## Response to comments by Referee #1 of EGUsphere-2024-3857

**Figure AR1:** Normalized radiance (blue) and accumulated signal for an OSF of two (orange) for two cases: Radiance only comes from the gap for read-out (left) and the radiance is 80 % in the surrounding in comparison to that in the gap (right).

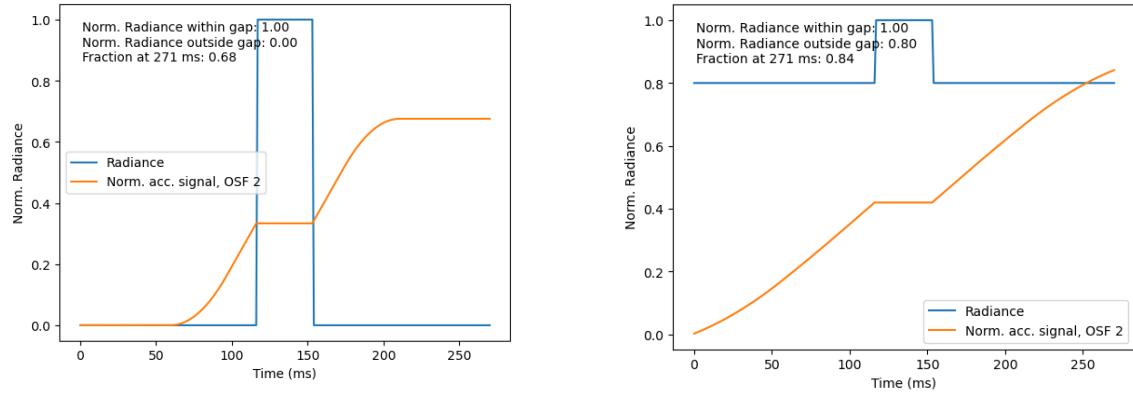
**SC3 (line 110):** *The spatial sampling is not affected, but I would expect an impact on the the spatial energy distribution function. Can you please comment on this?*

Authors' response: We did idealized tests about this in the context of this study where we convolved the signal with the IFOV, assuming a perfect instrument with rectangular FOV and same sensitivity at the edge as in the center. When doing this, the signal for OSF = 2 is reduced to a minimum of 68 % when the signal **only** comes from the gap created by the detector read-out, see Figure AR1 in this response. Hence, even if the whole signal comes from a region which is never measured by the middle ALT

detector pixels, the signal still is 68 % because of the IFOV of 0.4 km. This is an extreme case and more realistically, the differences in and outside the gap will be much smaller, see e.g. right panel of this figure, where the radiance is 80 % of that in the gap and the fraction is 84 % of the radiance after 271 ms. Therefore, yes, it has some impact on the distribution of the signal but it is considered to be small, which resulted in the sentence in the manuscript.
